CONSUMERS POWER COMPANY

Docket No 50-155

Application for Amendment No 4 to Operating  
License DPR-6

Change No 34

Figure 8.8

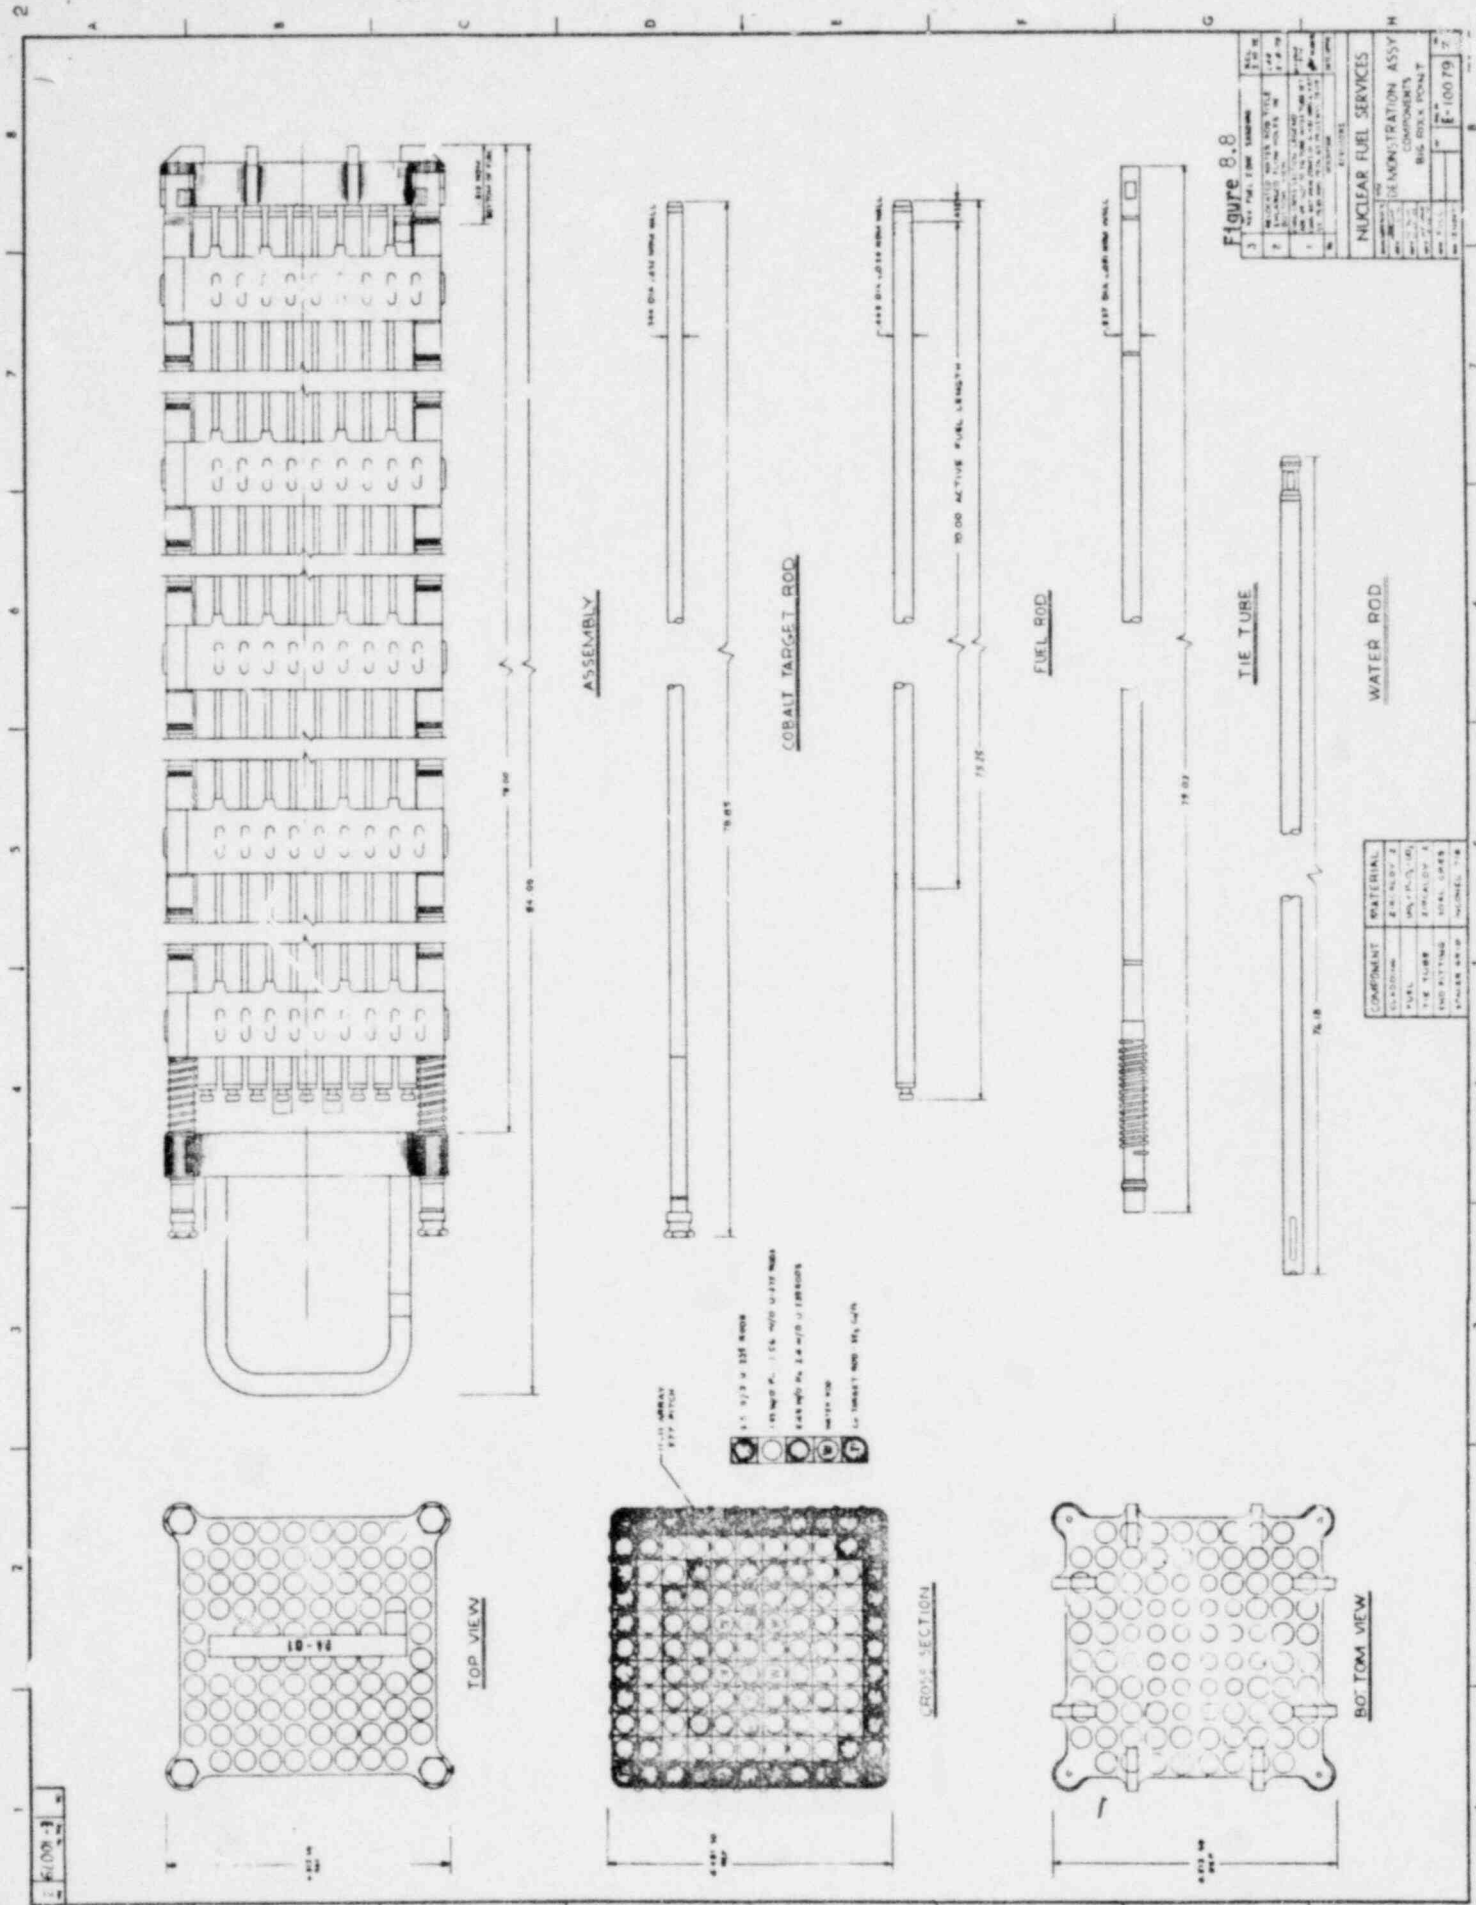
Add Figure 8.8 - Nuclear Fuel Services Inc, Demonstration Assembly.

The NFS-DA fuel fits the same physical envelope as other Big Rock Point fuel assemblies and is fully interchangeable with them. However, the NFS-DA utilizes a mechanical design that is unique (see Figure 8.8). The tubes in the corner positions serve as the structural members to tie the assembly together, as the spacer grid capture rods, and as the cobalt target rod housings.

The fuel rods are positioned by five spacer grids. Previous Big Rock Point fuel designs accomplished this by providing three intermediate spacer grids and employing fuel rods with end plug shanks that fit into holes in the upper and lower end fittings.

The lower end plugs of the NFS-DA fuel rods rest on the lower end fitting and the upper end plugs stop short of the upper end fitting. Each rod is free to expand axially, independent of other rods in the assembly.

The lower end fitting is similar in appearance to those of earlier Big Rock Point fuel designs (ie, Type F), except that it has its coolant flow openings graded in size from the center outward to redistribute the jet formed by the existing channel support tube orifice located beneath the fuel and is not drilled to position fuel rod end shanks. The coolant flow openings in this lower end fitting were designed to be compatible with the existing support tube orifices as well as with the new orifices which are being used to replace a portion of the existing orifices. The upper end fitting is completely removable so that any fuel rod may be removed from the assembly and examined or replaced, if desired.

Four nonfueled tubes are positioned in the inner regions of the fuel assembly. They are made of the same material, diameter, wall thickness and overall length as the fuel rod cladding. The upper end of these tubes is fully open but the lower end has a special end plug with side openings to admit coolant to the inside of the tube. These end plugs rest on the lower end fitting like those of the fuel rods.

FIGURE 1

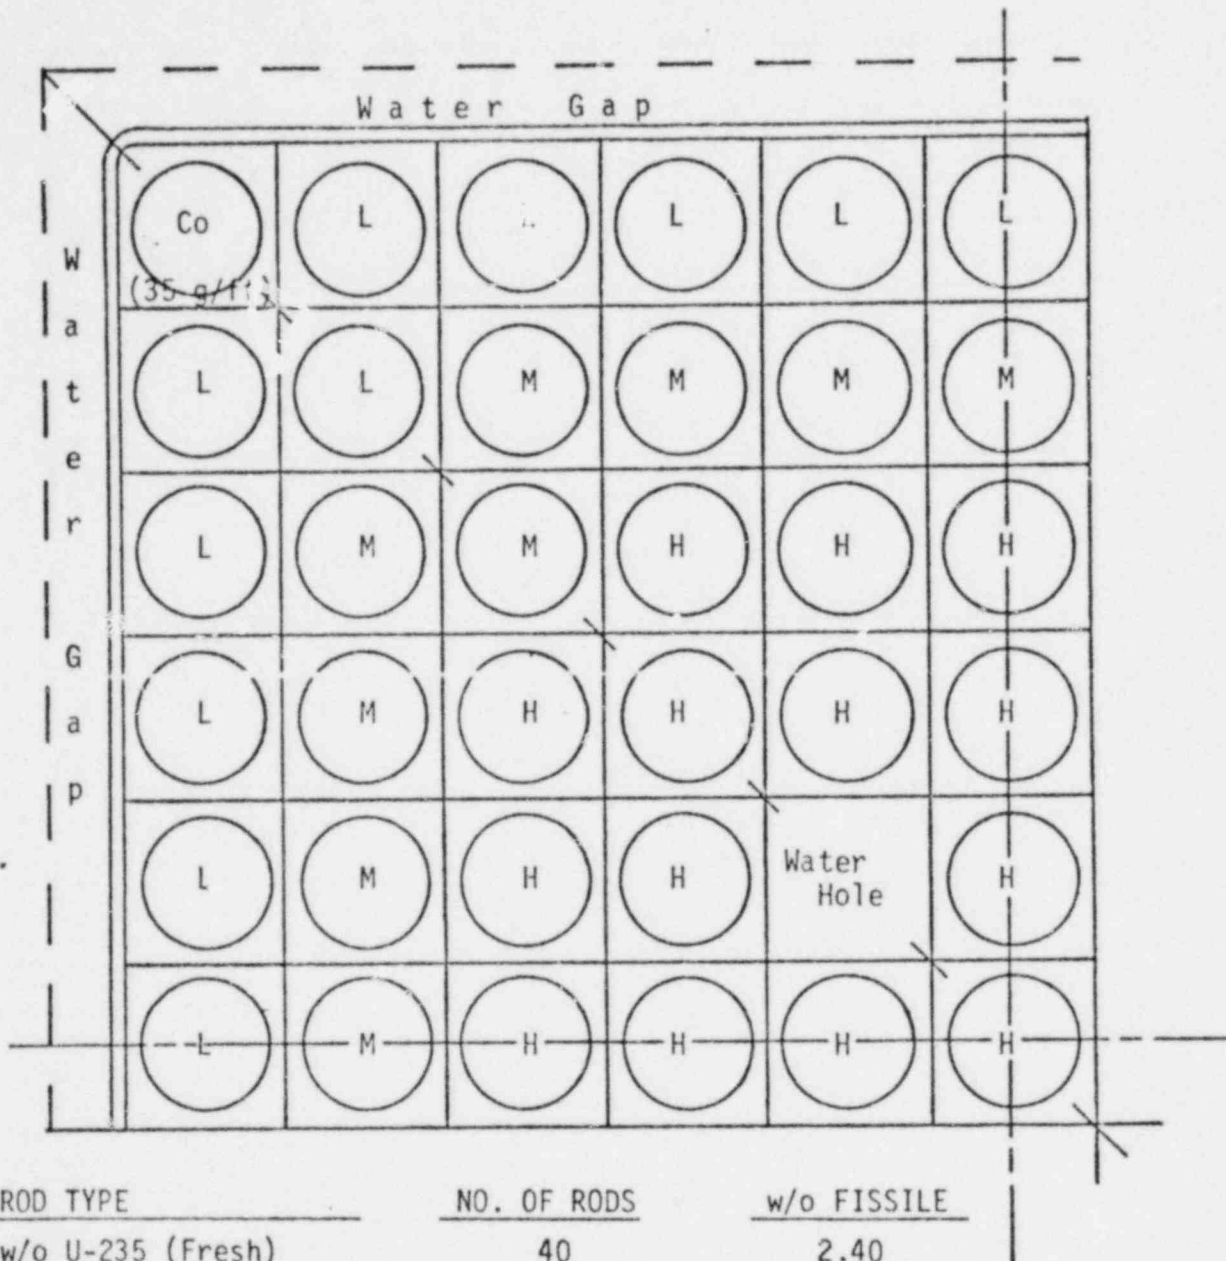
The NFS-DA fuel is designed to achieve an average burnup of 15,000 MWd/MTM during three (3) cycles in the reactor. The assembly average enrichment is 3.31 w/o fissile (Pu-239, Pu-241 and U-235), distributed as shown in Figure 1 (attached) and in accordance with the detailed mass balance given in Table 2 (attached). Beginning-of-life (BOL), normalized rod power distributions within a fuel assembly are shown in Figures 2 through 4 (attached) for uncontrolled, hot operating conditions at 0%, 25% and 40% void planes. The lack of rod power symmetry in the assemblies is due to nonuniform burnups assumed for three surrounding assemblies in a two-by-two unit assembly group. This arrangement of fuel, with varying degrees of depletion, around a fresh fuel assembly, was employed for the rod power factor evaluations rather than one that assumes the assembly to be inserted in an infinite array of identical fresh fuel because the former represents a realistic evaluation of the environment these bundles will experience.

FIGURE 2

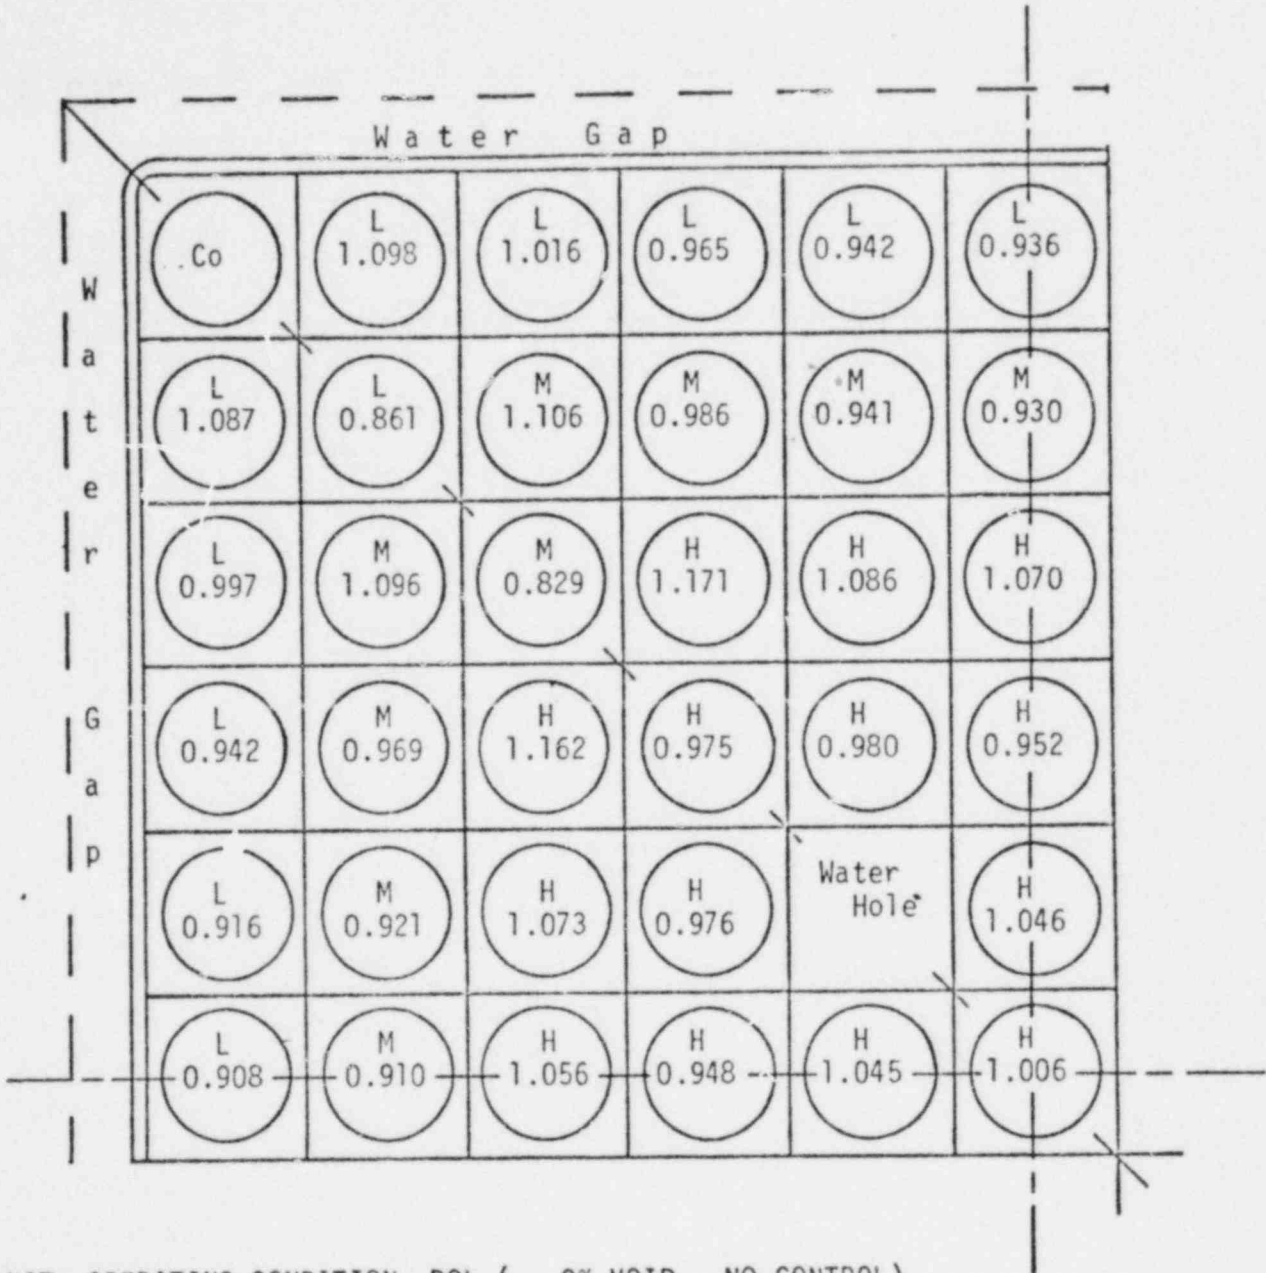
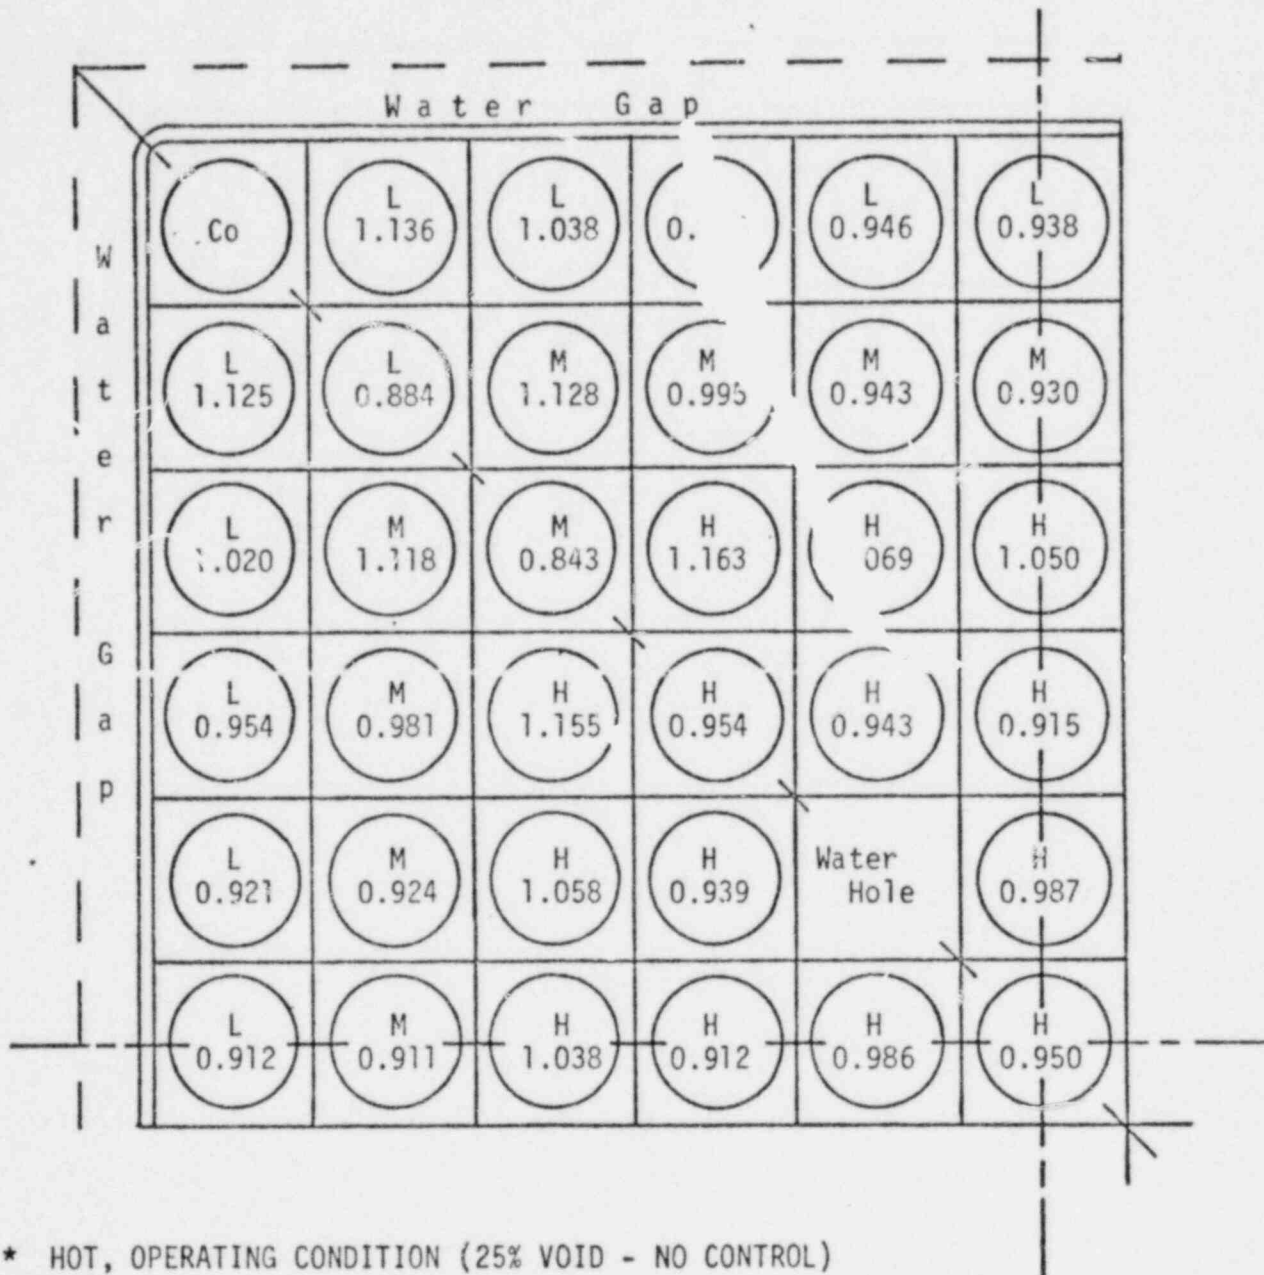
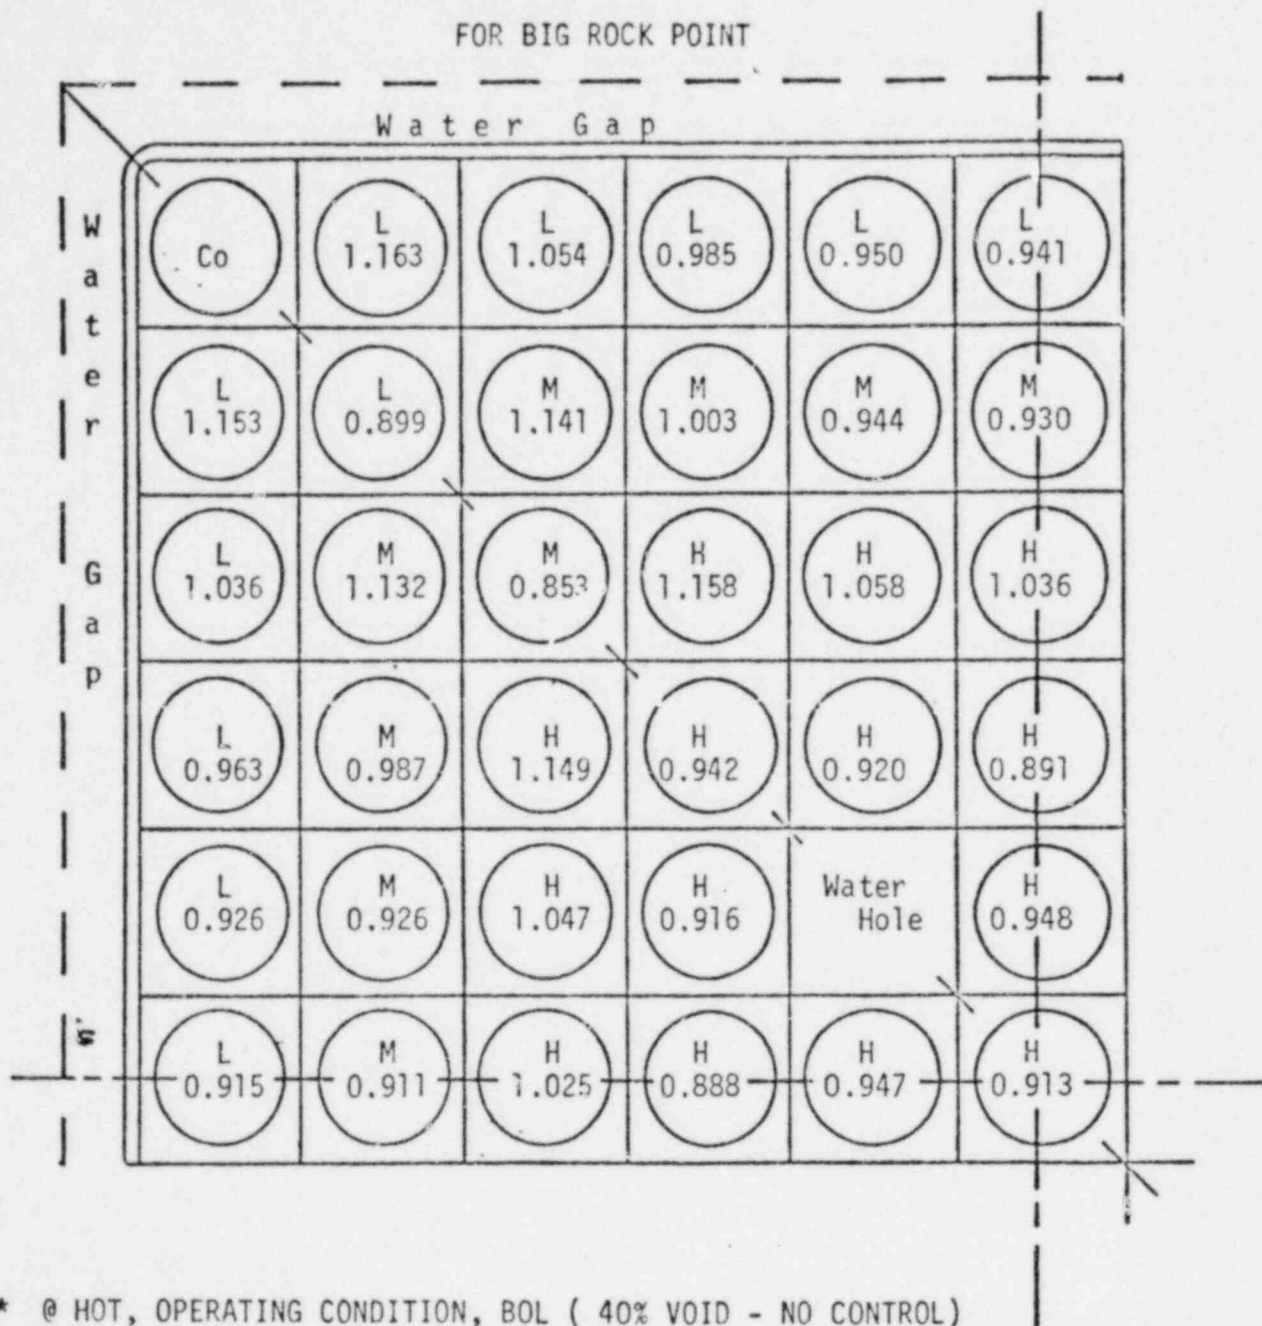
The local peaking factor depends upon the interaction of the effects of fissile material distribution in the fuel rods, the assembly internal water to fuel ratios, the void fraction within the assembly and the exposure. Figures 2, 3 and 4 (attached) show the local power distributions at 0%, 25% and 40% void planes at beginning of life. These are comparable to or slightly below what would be expected from previously licensed fuel in the BRP reactor. Accordingly, with comparable fuel assembly pin power peaking factors, the same coolant flow rate, 17% more heat transfer surface area, and an equivalent or less severe power response to reactivity insertion events, the critical heat flux margins in the NFS-DA fuel will be greater than that of 9 x 9 array fuel under both steady state and transient operation.
